# **SPARC Enterprise M3000/M4000/M5000/ M8000/M9000 Servers**

Product Notes for XCP Version 1124

Manual Code: C120-0066-02EN  
January 2019, Revision A

# M9000 Servers Installation Area

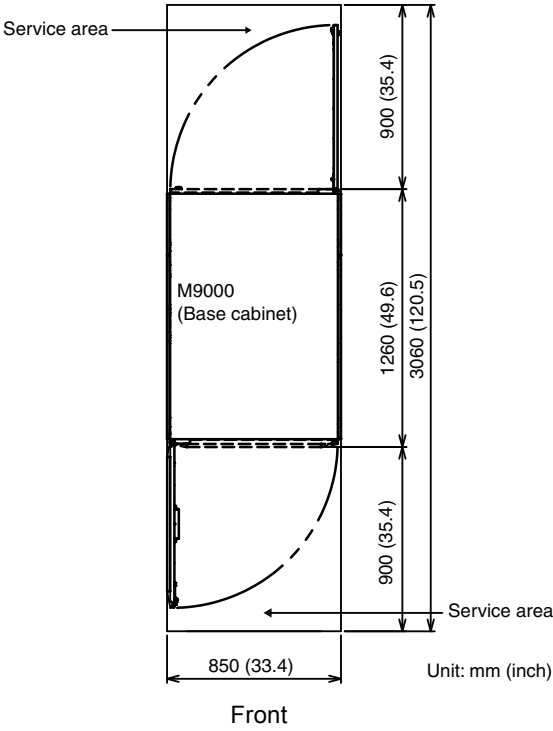
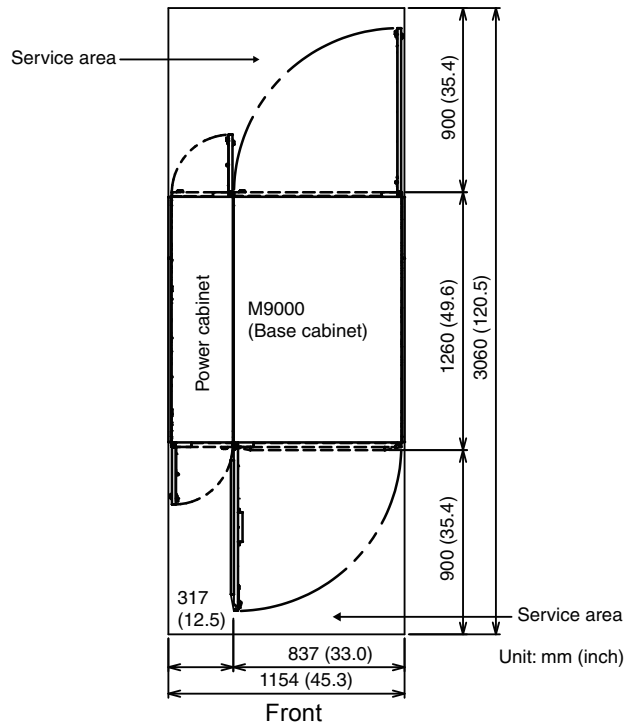
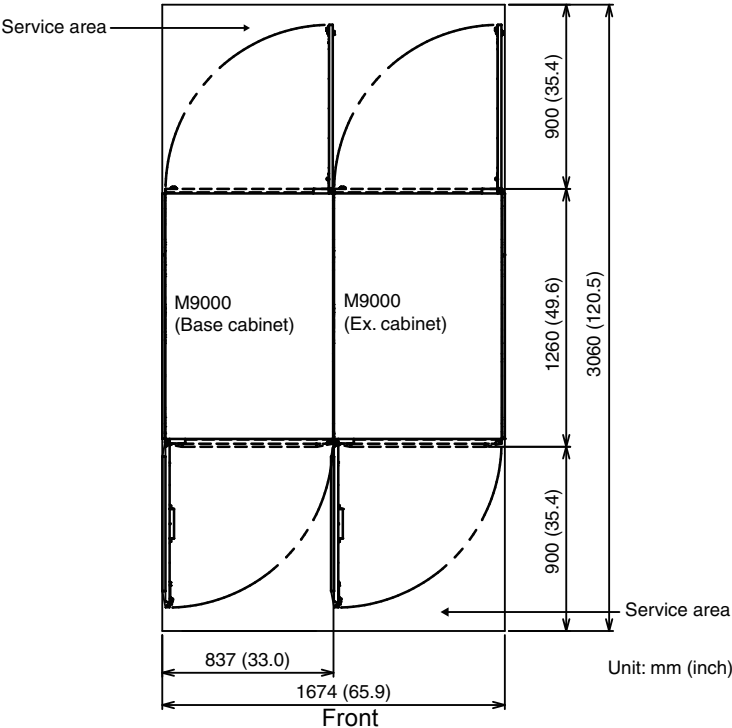
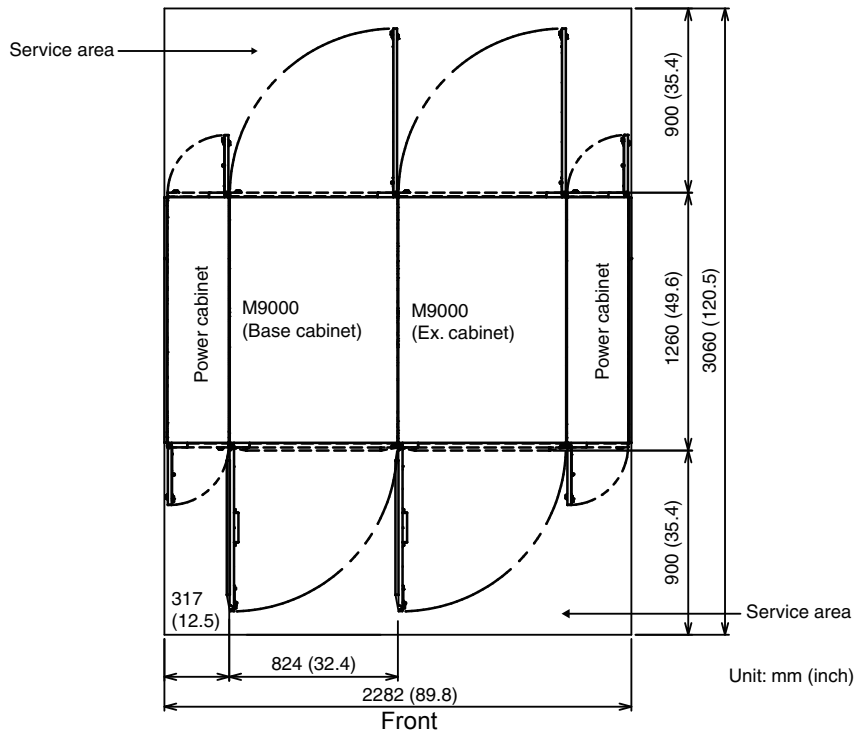
SPARC Enterprise M8000/M9000 Servers Site Planning Guide	1-18	A part of values in inches on FIGURE 1-13 to FIGURE 1-16 will be corrected. For detail, see <a href="#">“M9000 Servers Installation Area” on page 125</a> .
	1-35	For the order number of Vibration-proof bracket and Vibration-proof feet, see <a href="#">“Miscellaneous Information” on page 129</a> .
SPARC Enterprise M8000/M9000 Servers Service Manual	7-8	The mounting location of I/O Unit (IOU) indicated on FIGURE 7-4 will be corrected. For detail, see <a href="#">“I/O Unit (IOU) Mounting Locations” on page 128</a> ."

The following information supersedes the information in the *SPARC Enterprise M8000/M9000 Servers Site Planning Guide*
